The proposed use of the new property will be as a single, 1.5 storey 3-4 bedroom family dwelling. Has been designed using Passivhaus design methods as the applicants are interested in achieving an energy-saving and comfortable retirement dwelling.

Following queries raised on Monday, the 15th of April, 2019 on the location of the proposed dwelling, relative to adjacent properties, we have prepared a separate Site Block Plan (A03) to show the distances between the proposed dwelling and existing properties on all (relevant) sides – to the North, west and South. To the east of the proposed development site is only additional land under the applicant’s ownership which ends at the River Seven, so this area is not as subject to overlooking from other properties as it is outside the current limits of existing development.

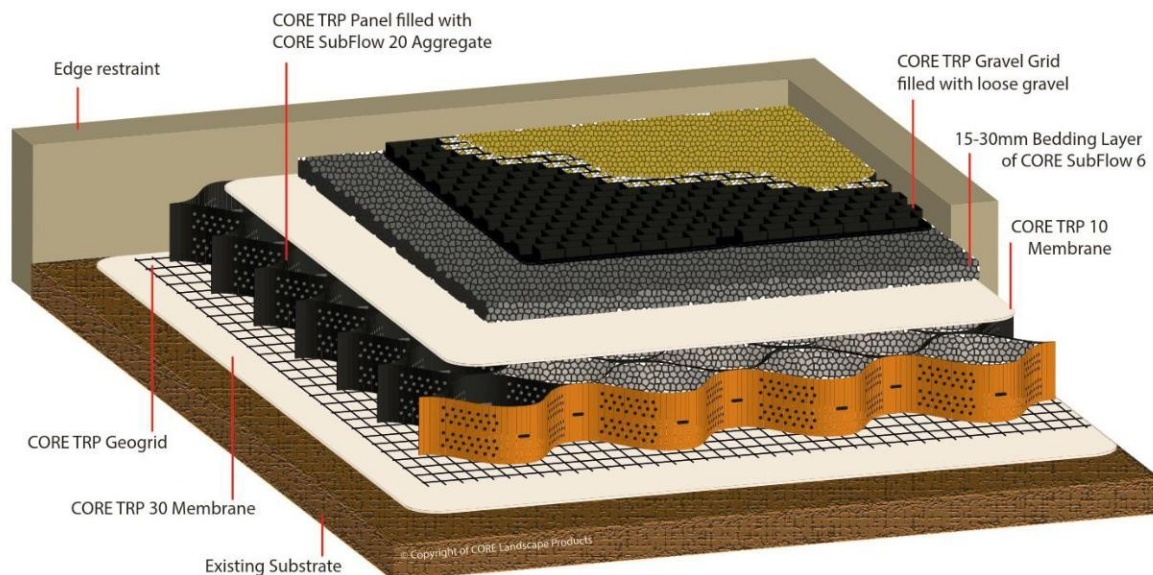
Following query raised by Niamh Bonner – we propose to install the drive using low-impact methods and a system to protect the root zones of both the trees on site and the adjacent trees (that are under tree protection orders – now annotated on the revised site block plan.)

Below is a construction build-up of one of the systems under consideration. Other similar systems are available and may be considered, however, all share the same, “low impact” and “no-dig” methods suitable for avoiding the risk of any damage to tree roots. A method statement for the system below is also attached – in APPENDIX A.

Following discussion with both Niamh Bonner and the Applicants we have revised the proposed finish for parts of the access drive / turning and parking areas. The system pictured above is proposed for use in those areas nearest to the root protection zones of the mature trees on the adjacent southern boundary as well as for the surface directly beneath the Carport – please see the outline of this areas on the revised Site Block Plan drawing A02 Rev. E. Other access drive areas to be as shown on the same drawing.

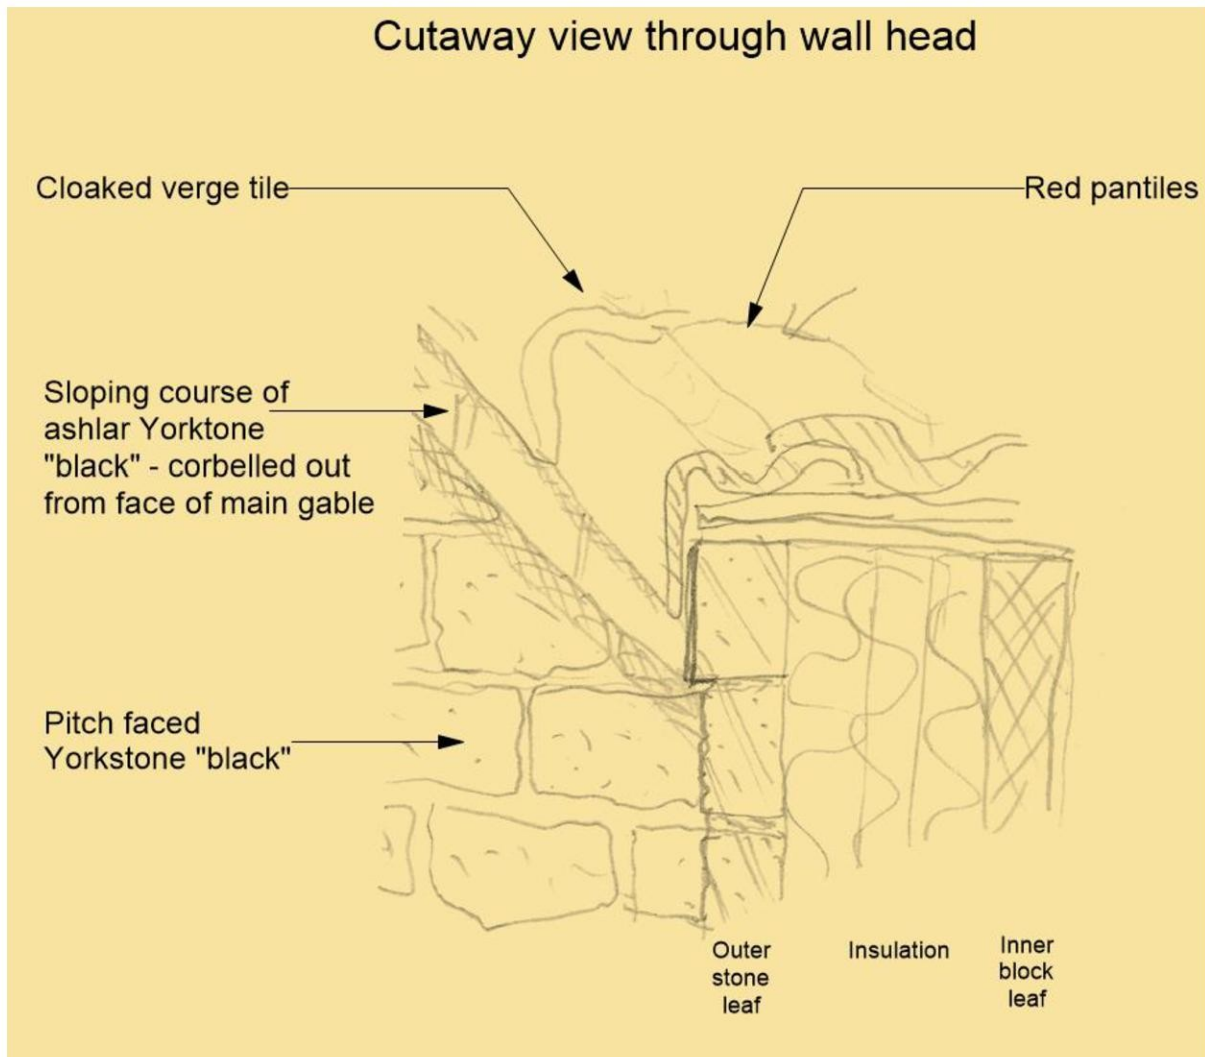
Niamh Bonner has expressed a preference for a darker slate roof finish to the proposed dwelling. However, the Applicant's would prefer a red pantile roof over a slate roof. It is felt

that, based on the images above – when compared with the approach below, adopting integrated PVs can achieve a suitable aesthetic appearance that is certainly preferable to surface mounted PVs – as shown below.

We have also reduced the number of Photovoltaic panels on the roof down to 20 panels (from 28) and consolidated their arrangement in relation to the rooflights to be more coherent and aesthetically pleasing. This revised layout can be seen on the re-submitted South Elevation, drawing SK03.

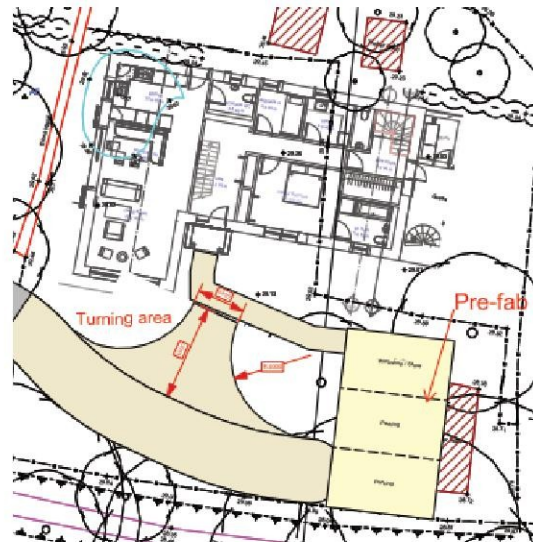
The new access has been designed based on a preliminary layout provided to Stephen Boyne of North Yorkshire Highways. Mr. Boyne visited the site (on Tuesday, September 11th 2018) to comment on a previous site layout – as shown in the image below.

1. *"there seems to be an issue with traffic speeds through the village here, so I would wish to ensure that, for any new access, visibility can be achieved in accordance with the maximum Stopping Sight Distance values as given in Table 7.1 in Manual for Streets"*
2. *"some of the hedgerow close to Pasture House and around the electric pole will all have to be cleared away to ensure that visibility. Ideally the little section of fence and hand-gate should be moved back too to clear the visibility splay."*
3. *"the domestic driveway may be reduced to 3 metres width away from the vehicular crossing section. The reversing / turning area directly in front of the carport would be satisfactory."*

With regards to item 1. Above, the required visibility splays are shown on drawing A02 As Proposed Site Block plan – as far as is practically possible for the scale of the drawings. The Applicants are prepared to make the changes requested in no. 2 above & they have been noted on the existing & proposed site block plans. In line with item 3. above, we have reduced the width of the driveway to 3 metres away from the drive access point – primarily to ensure the proposed drive can be accommodated in between existing trees on site.
